## **ADDENDUM NO. 2**

Issued: October 25, 2016

Project: Joplin Early Childhood Center  
Site Legal Description:  
JOP MISC  
BEG 1360.93' S & 50' E NW  
COR SE E 456.91' N 318.78'  
W 456.91' S 318.78' TO POB

Project No. 16054

G101

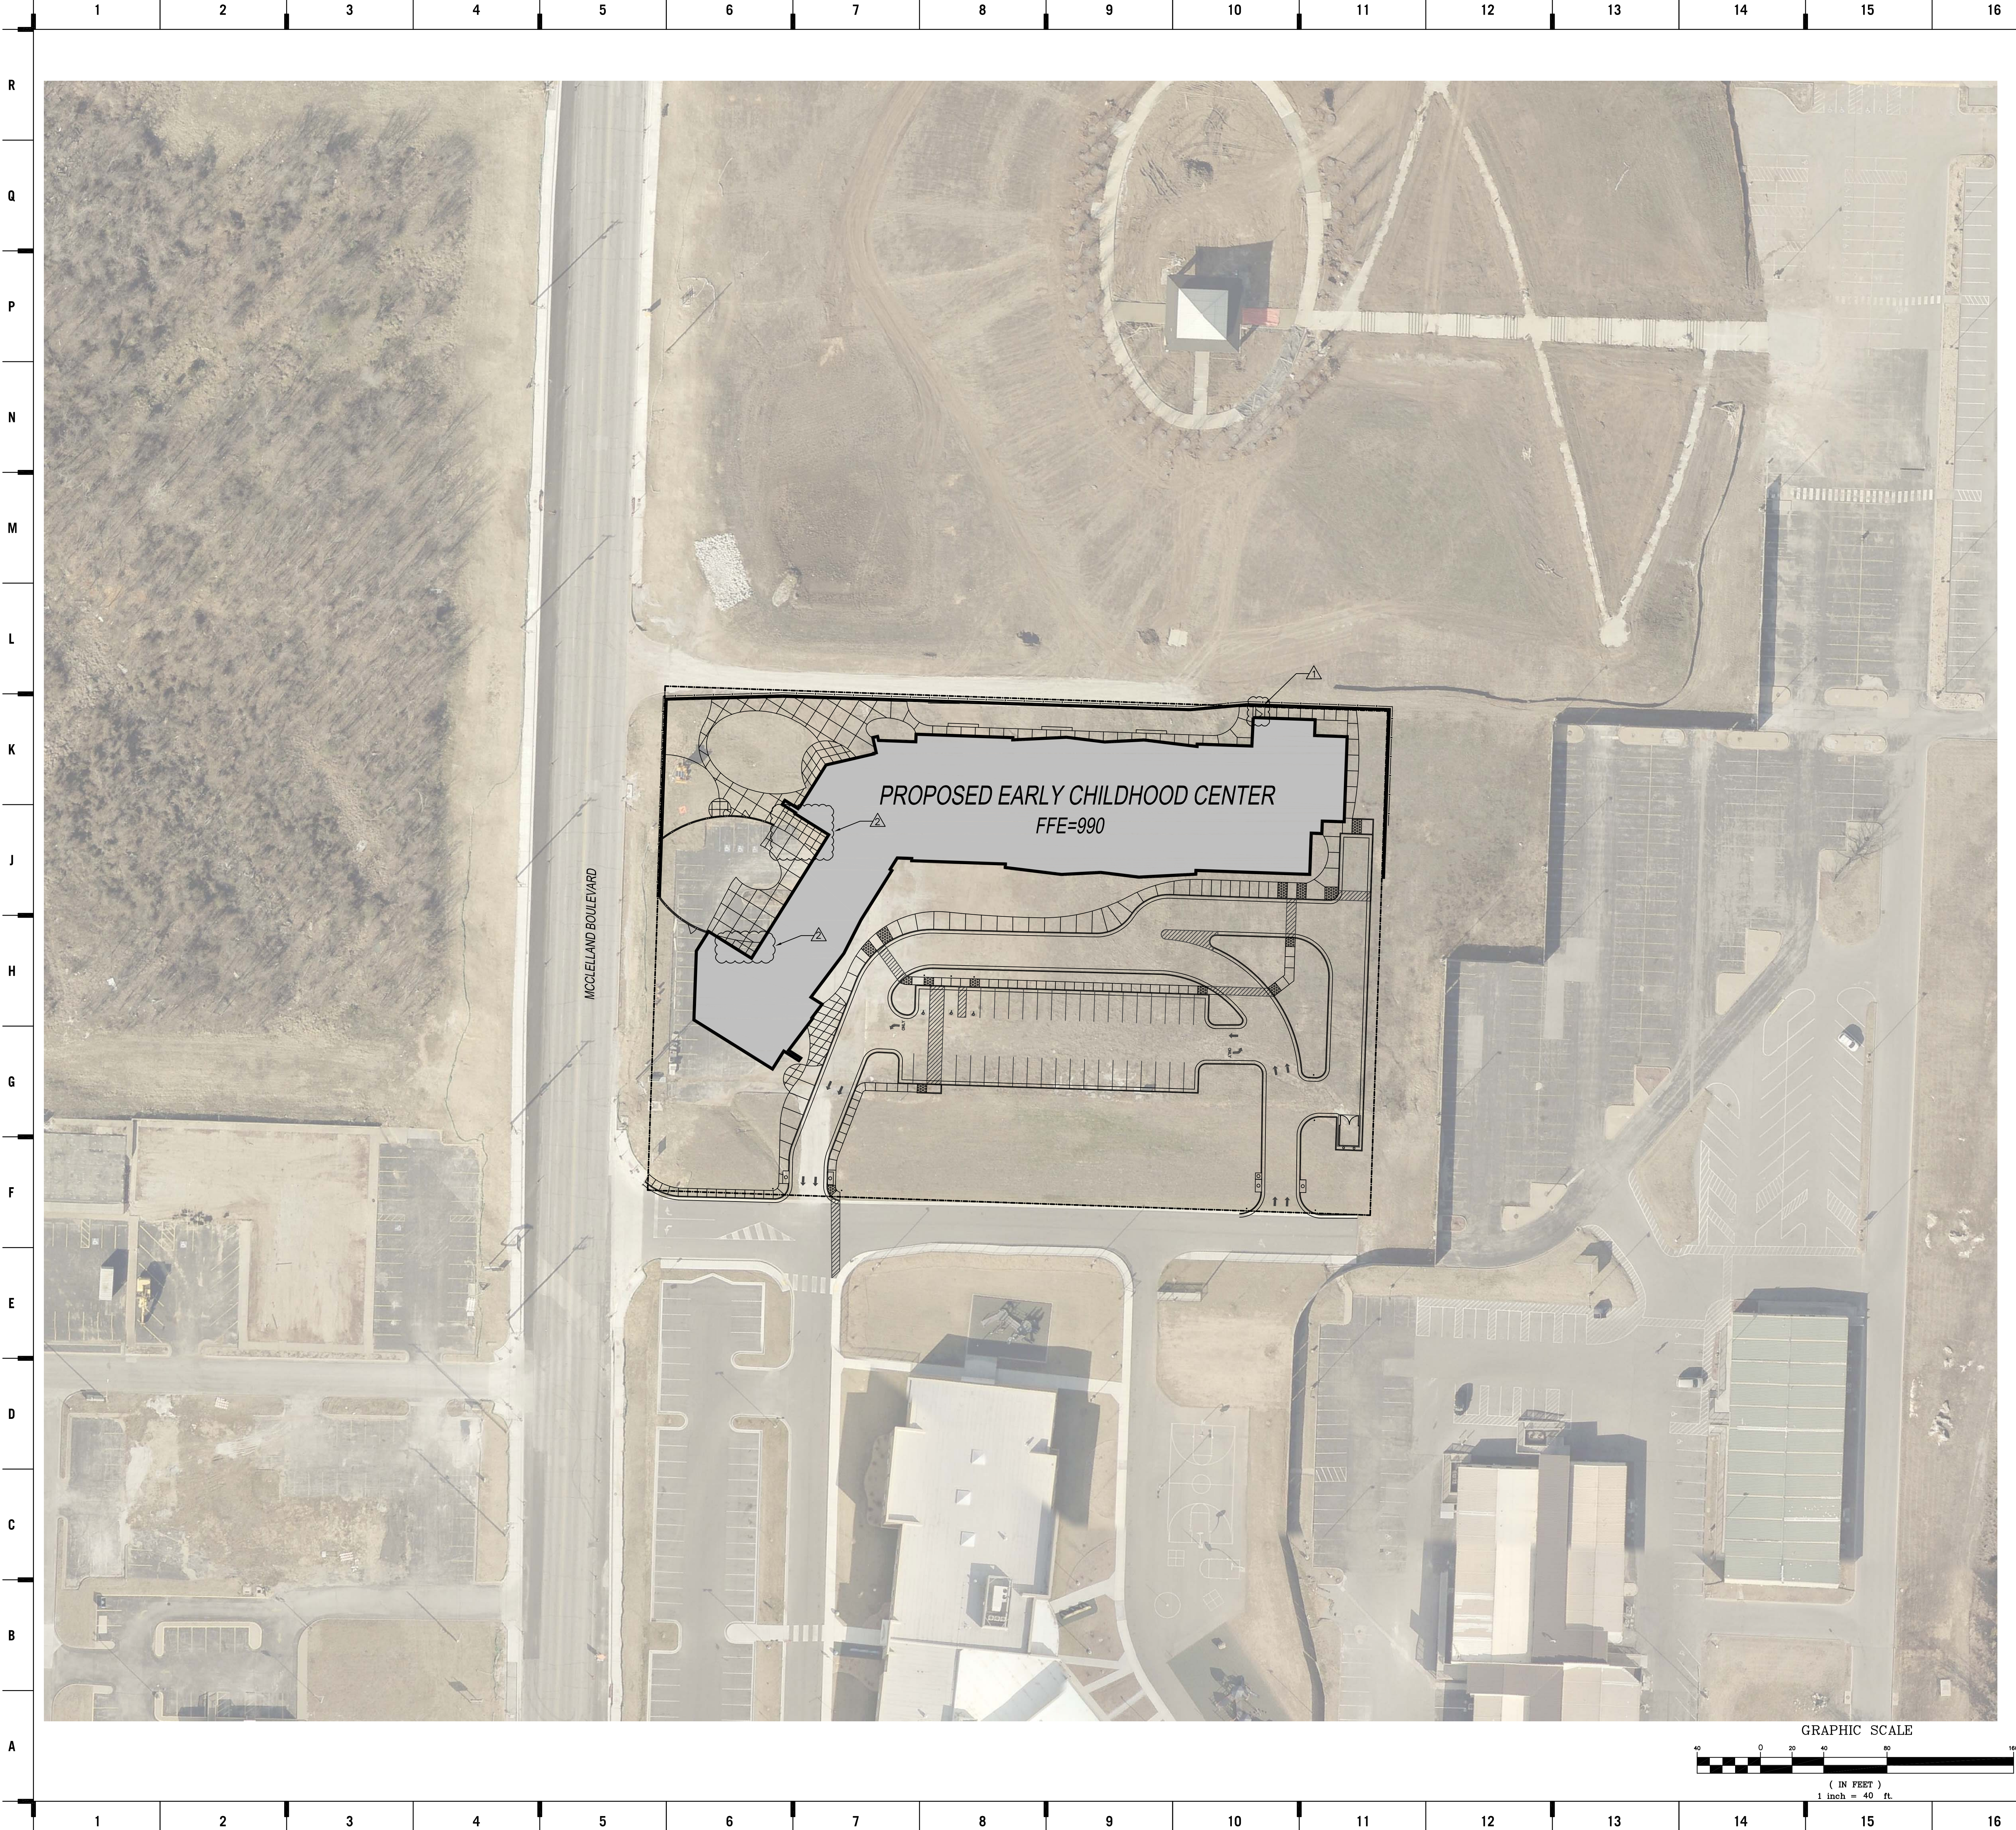
A17.1 REPLACE previously issued Sheet G101, with attached sheet G101 dated 10.25.2016. (Added a general note and flag pole base).

C103

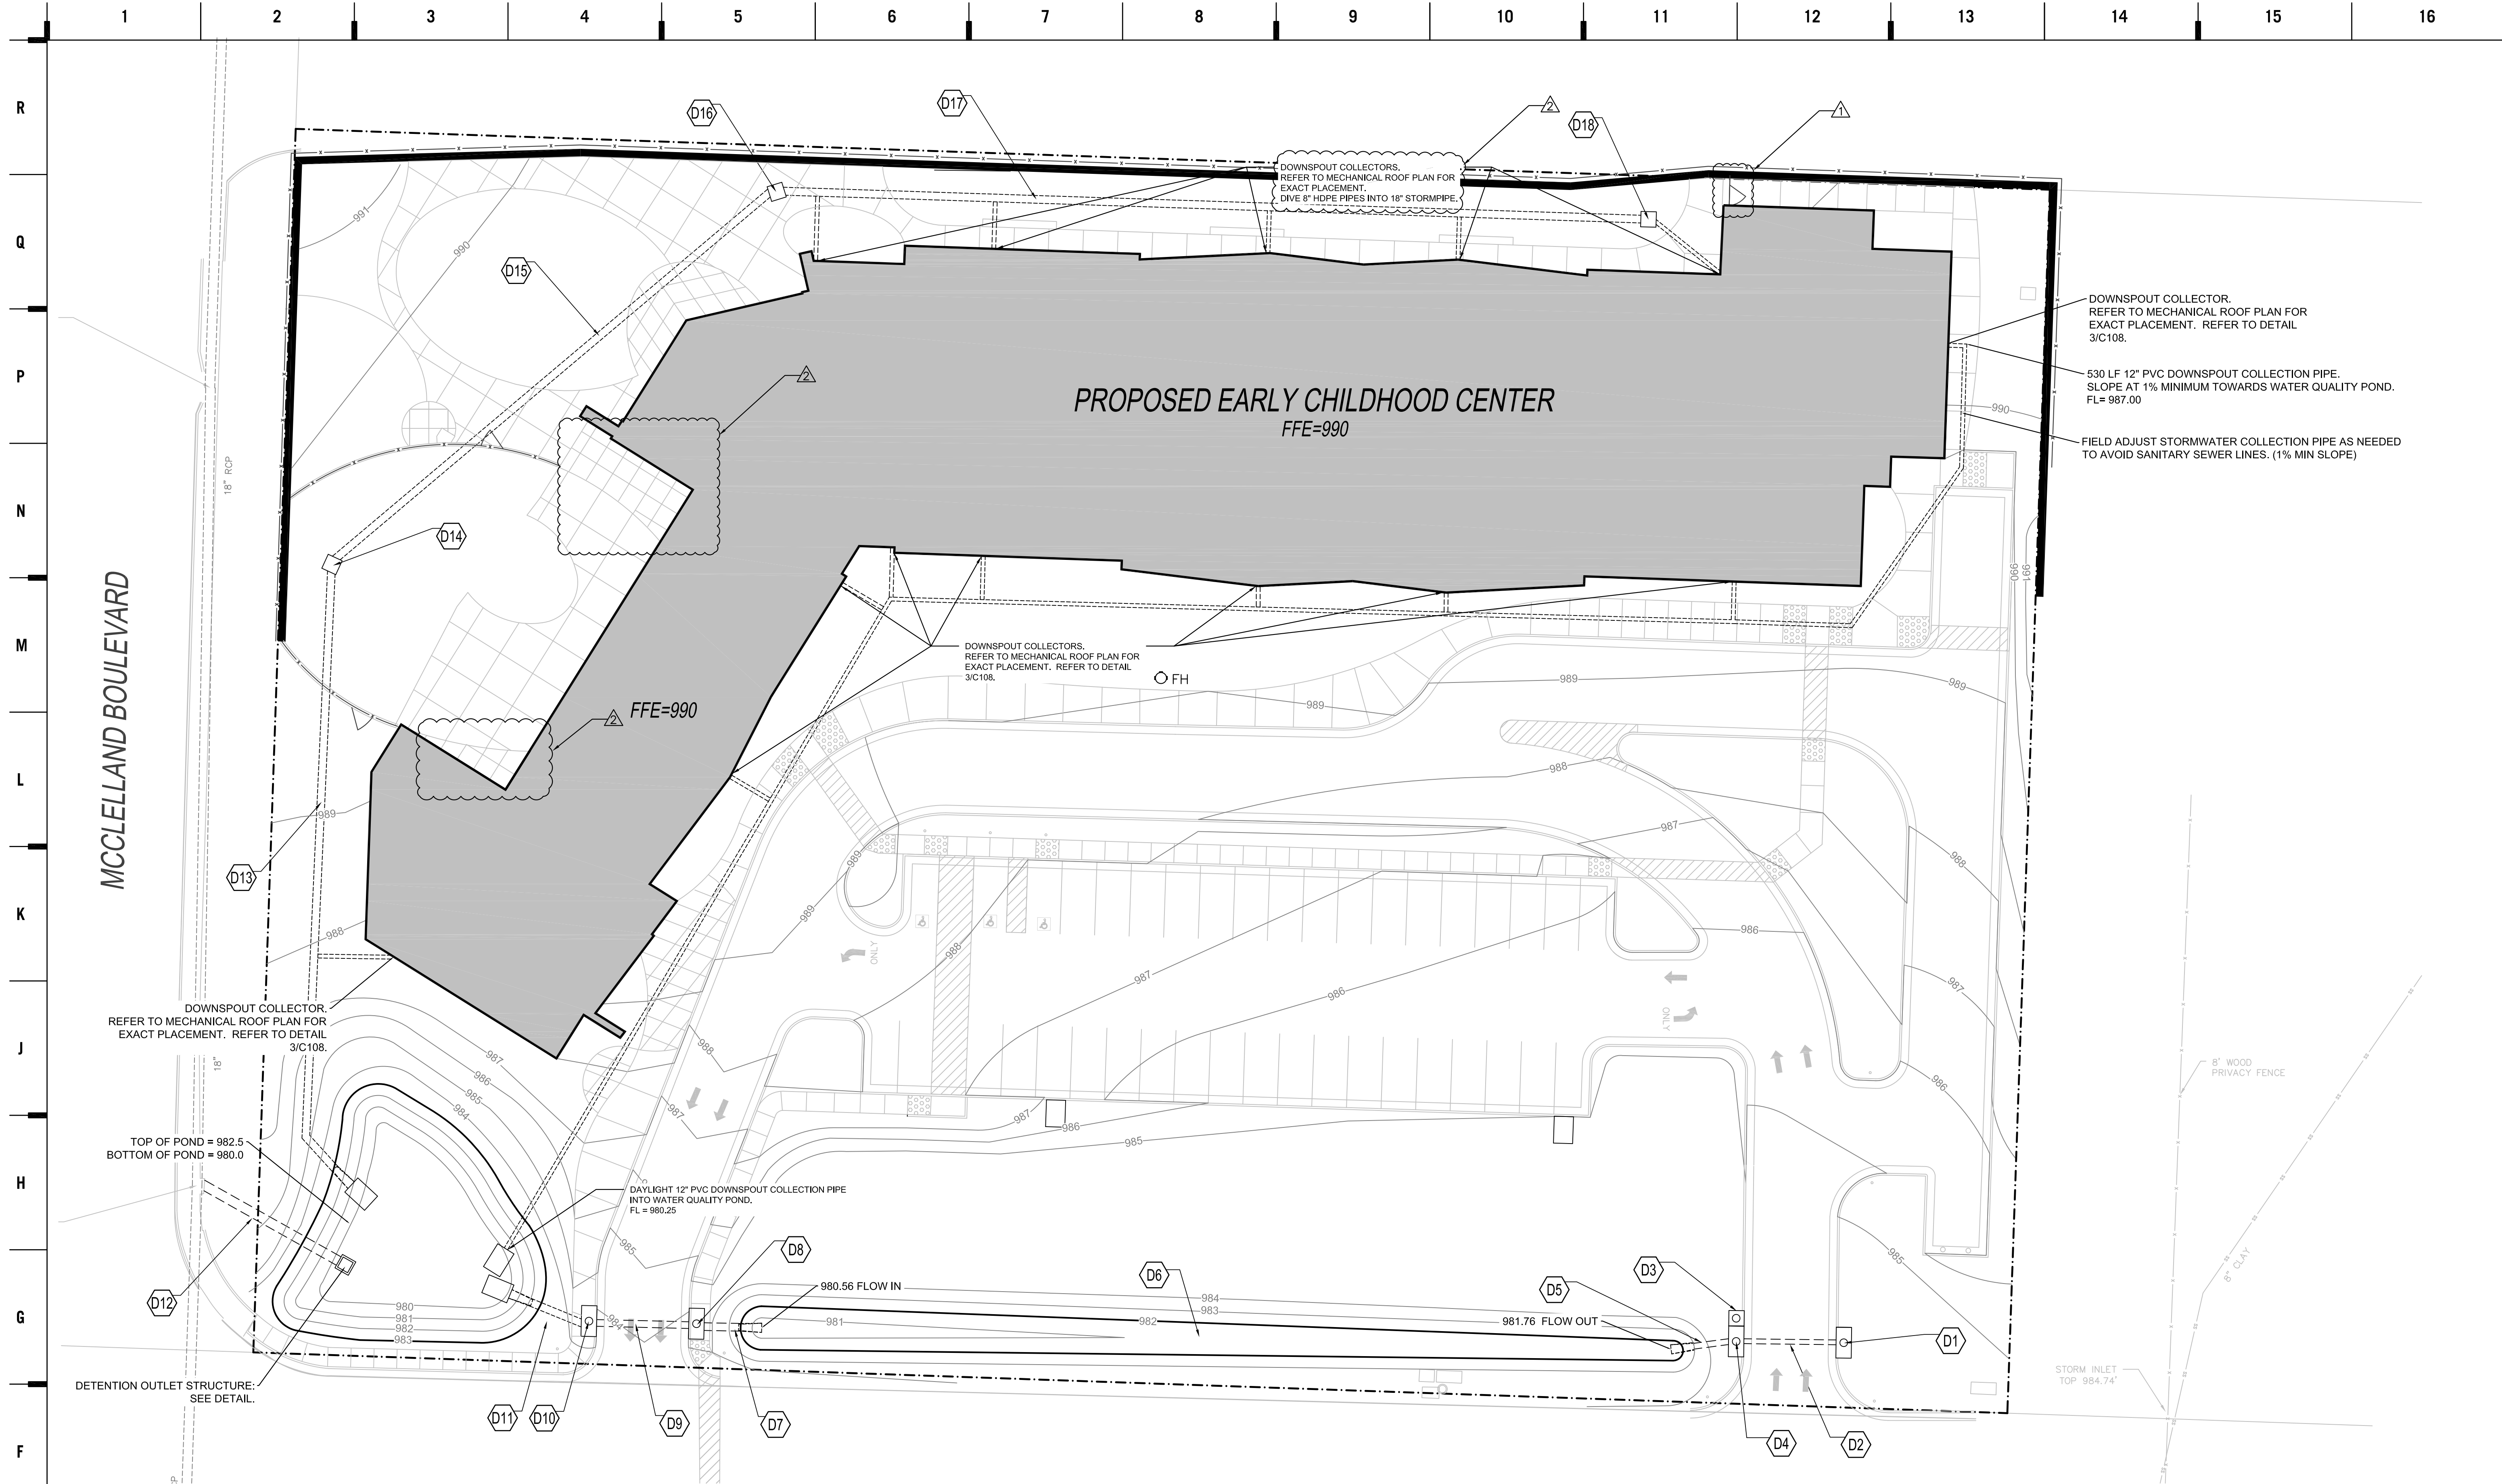
C3.1 Removed the planting beds w/in the daycare alternate footprint and replaced w/ concrete.

C104  
OF

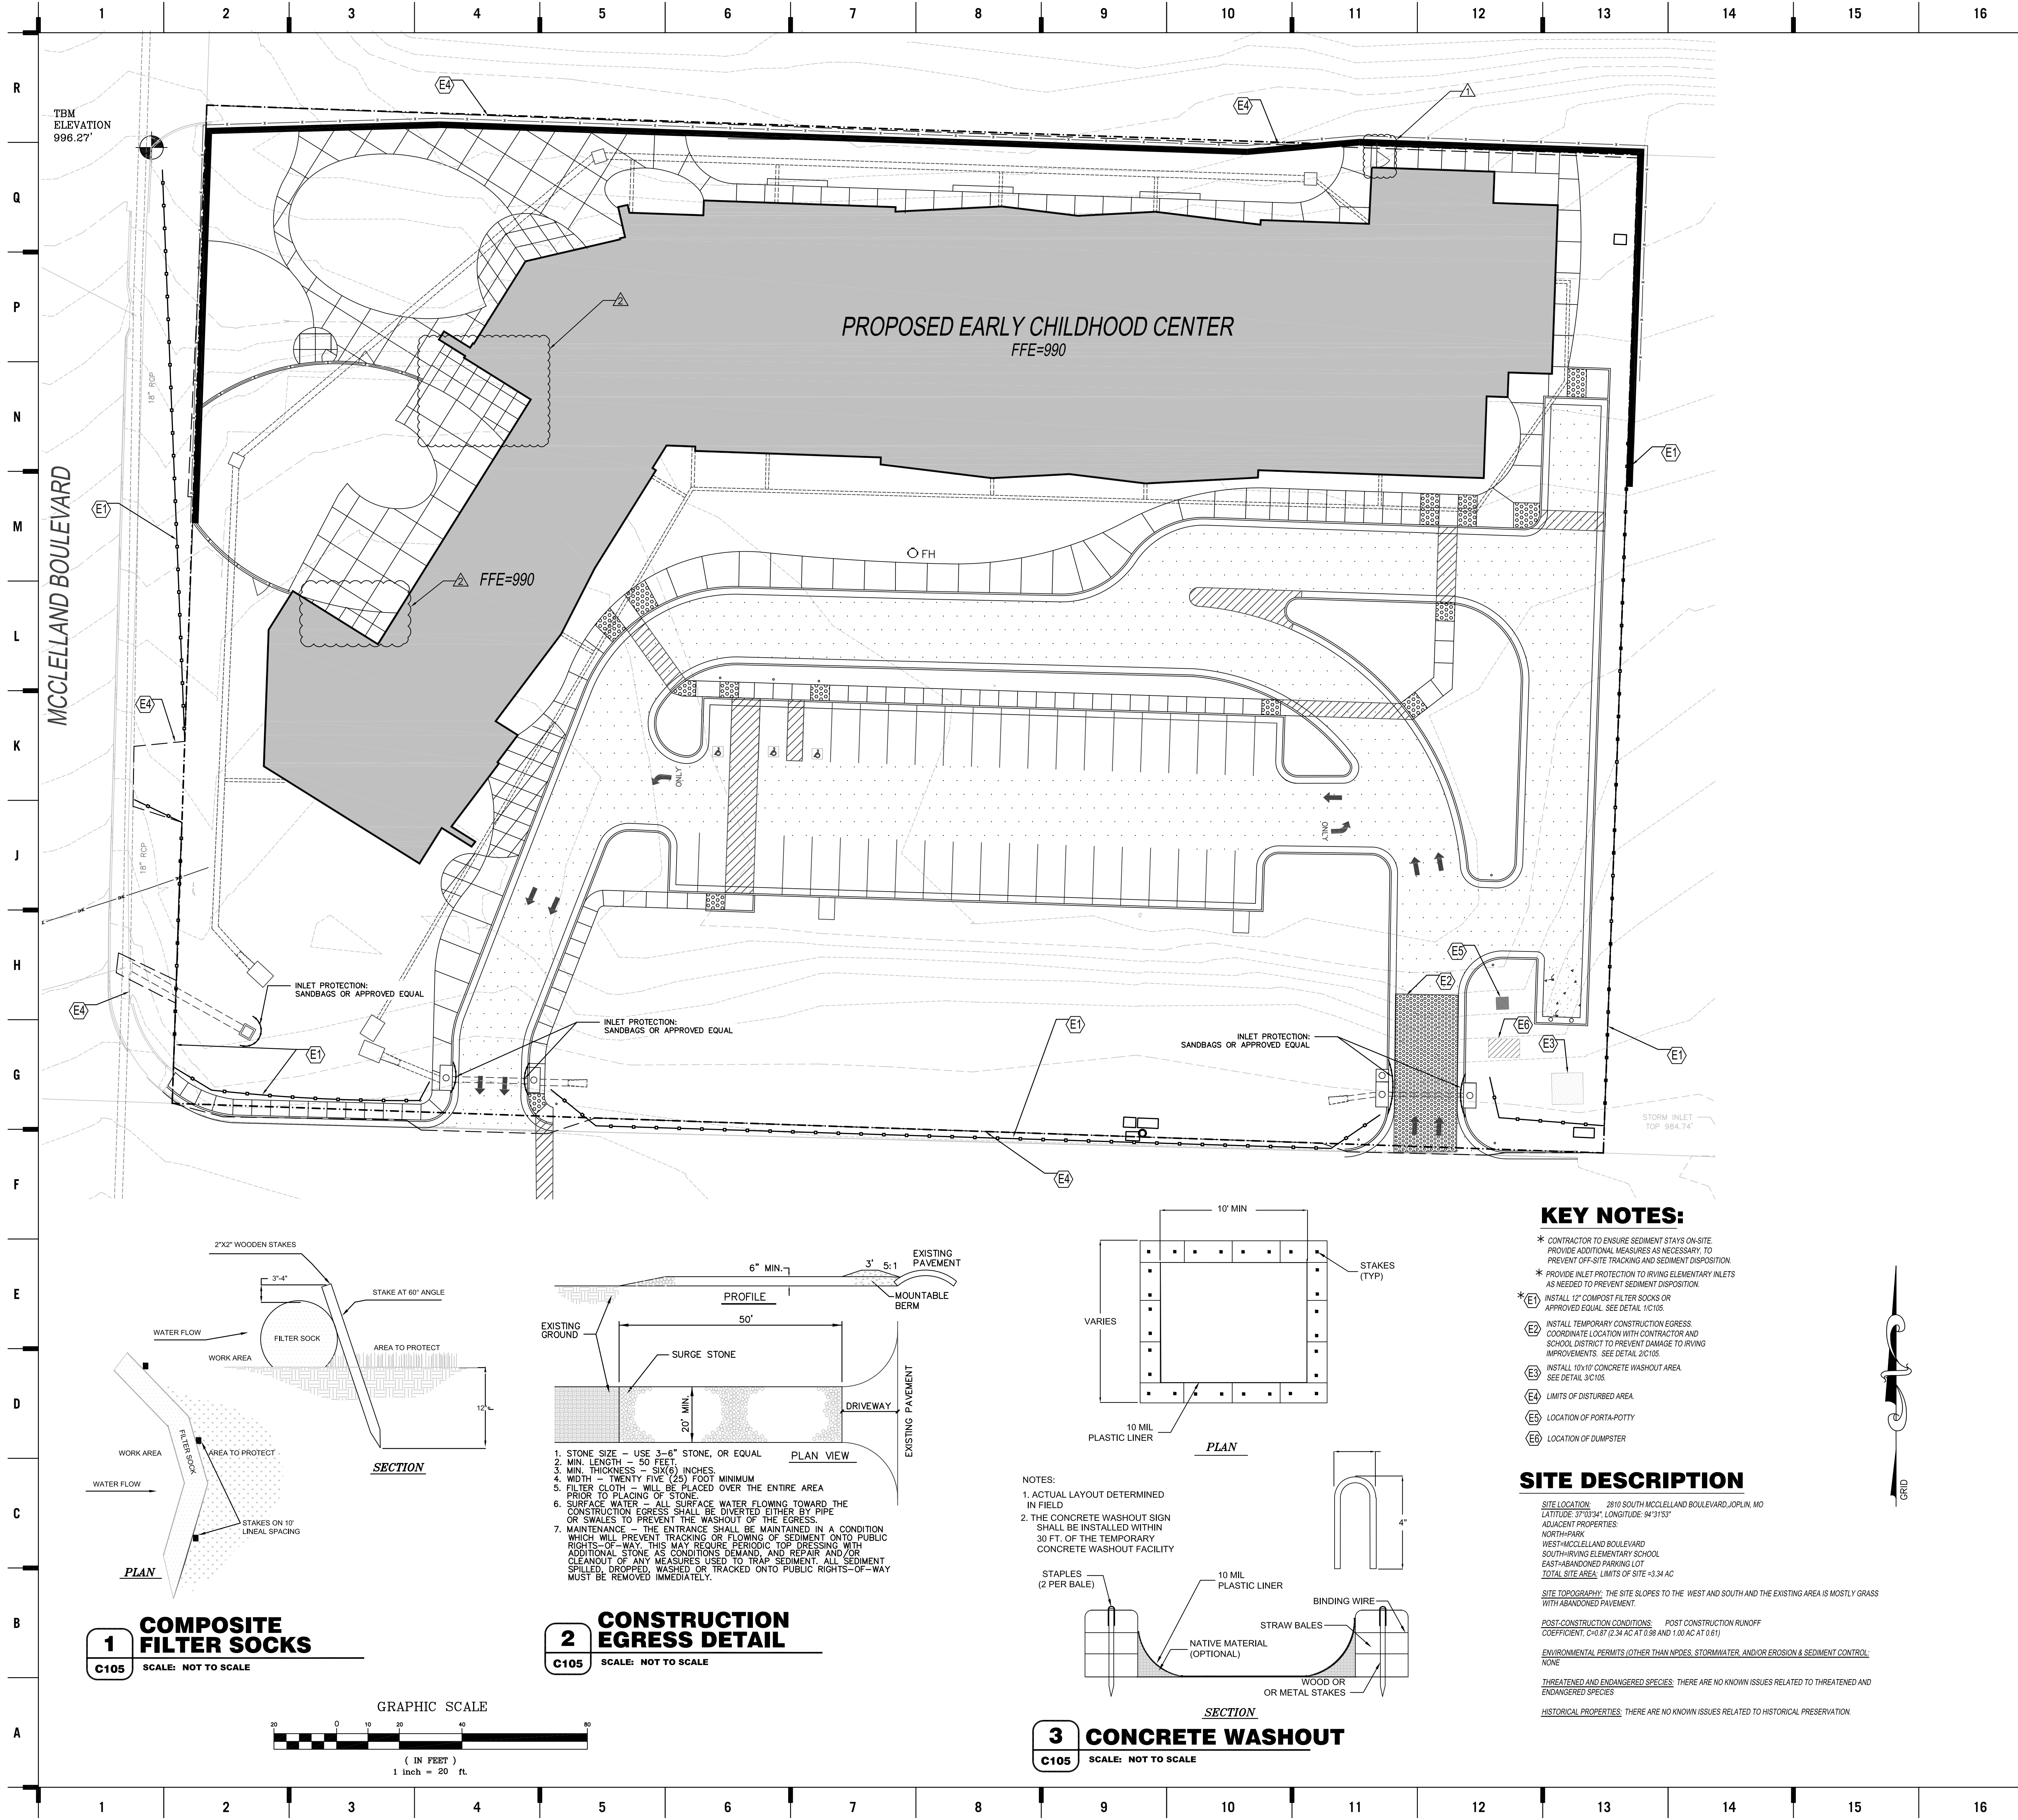
**G27 QUESTION: ON ADDENDUM SHEET C104 NOTE D17 CALLS OUT HDPE PIPE BUT SAYS 4X4? D15 SAYS IT'S HDPE 18". IS D17 24" PER THE NOTE ABOUT THE DOWNSPOUT DRAINS ON THE NORTH SIDE OF THE BUILDING?**

C4.1 Removed the planting beds w/in the daycare alternate footprint and replaced w/ concrete. Downspout note changed to dive 8" HDPE pipes into 18" stormpipe instead of 24". D17 size changed in Drainage Structures Index to show 18" instead of 4'x4' and Top elevation was changed to N/A. Area inlets were updated in the drainage structure table to show top elevation. Drainage structure table item D2 was updated and no longer shows top elevation. Water quality swale in drainage structures updated to show N/A for size. Water quality swale size shown with contours on sheet C103.

G27.1 Answer: D17 should be a 18" HDPE Pipe. The note for the downspout collectors will be changed to say dive pipe into 18" storm pipe.

**G2.1 Answer:** D17 should be an 18" HDPE pipe. The note about the downspout drains will be changed to dive 8" HDPE pipes into 18" stormpipe.
